Commonwealth Edison
One First National Plaza, Chicago, Illinois
Address Reply to: Post Office Box 767
Chicago, Illinois 60690

Subject: Dresden Station Unit 2
Use of ASME Code Case N-411
NRC Docket No. 50-237

Reference: Letter from J. R. Wojnarowski to H. R. Denton
dated September 30, 1985.

PUMP MODEL LOOP B
 (LOOP A TYPICAL)

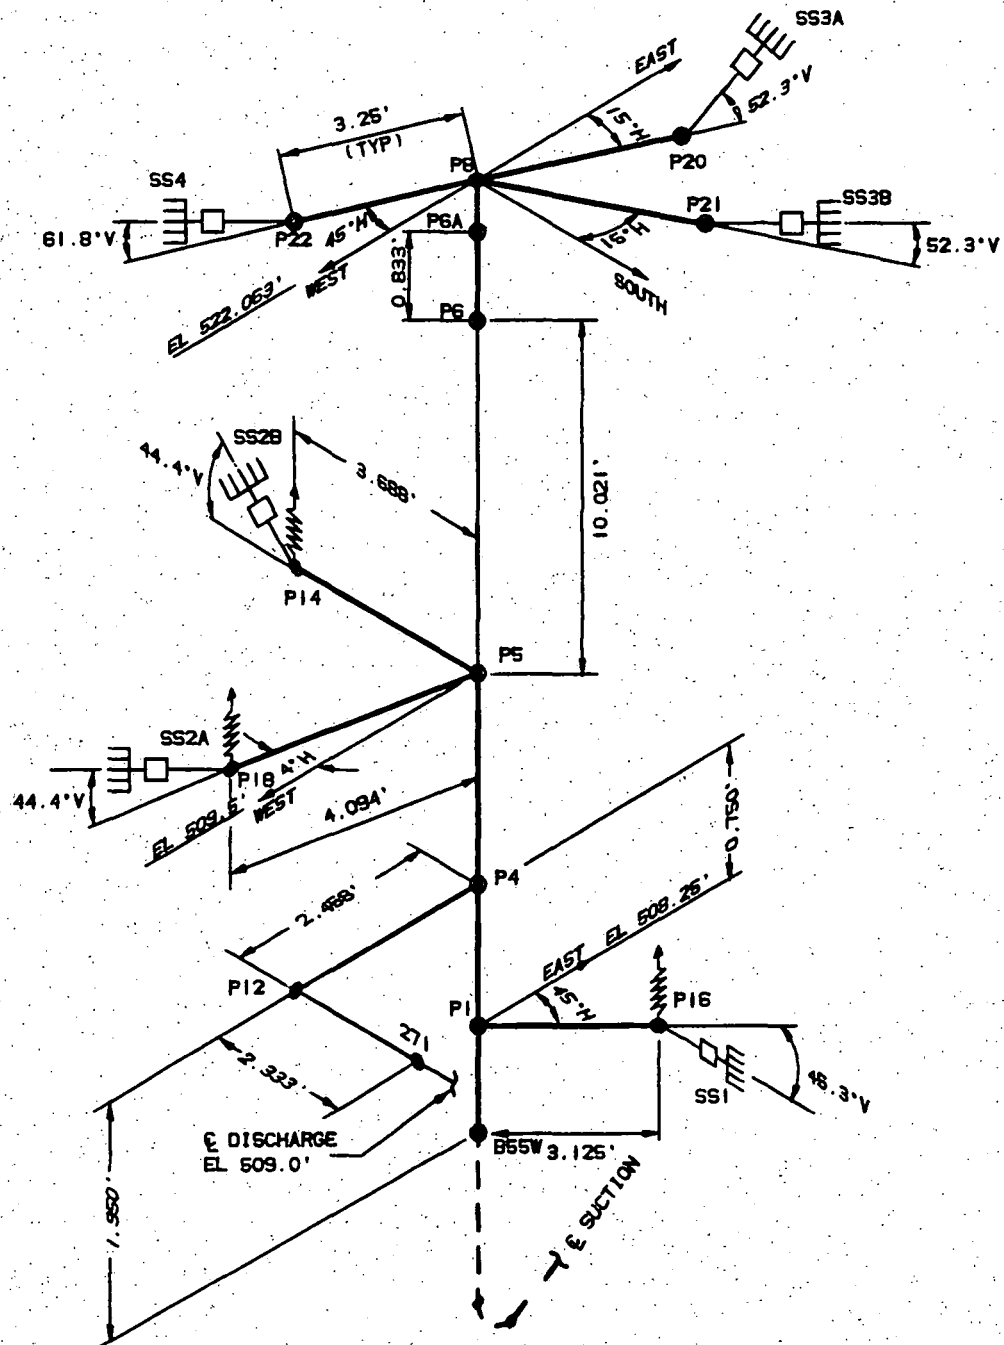
The Recirculation Pumps were modeled as shown on Figure 2. These pumps were included in the piping model in order to obtain pump snubber loads. Mass points were positioned along the length of the pump model to most accurately distribute loads to those snubbers. The pump, as modeled, has a least fundamental frequency of approximately 25 hertz. This frequency is largely due to the assumed flexibility of the pump snubbers.

The central concern of the NRC Staff was whether or not the damping contribution from the pump would be consistent with the intent of the Code Case N-411. Code Case N-411 specifies a damping versus frequency curve for piping systems, in which 5% damping applies for frequencies up to 10 hertz, and 2% for frequencies greater than 20 hertz. Between those two frequencies the damping is linear (e.g., 3-1/2% at 15 hertz). Basically, the Staff requires that the composite damping of the piping/pump system should be consistent with the N-411 damping curve. One way to demonstrate this is to show that the pump does not respond to frequencies below 20 hertz.

Based on the high fundamental frequency of the pump model (25 hertz), it can be concluded that the pump does not respond at frequencies below 20 hertz. To further confirm this, the mode shapes were reviewed. As expected, the pump does not have an individual response at modes below 20 hertz. Essentially, the pump acts like a rigid, lumped mass such as a valve. Code Case N-411 was developed from tests in which valves were included as in-line components.
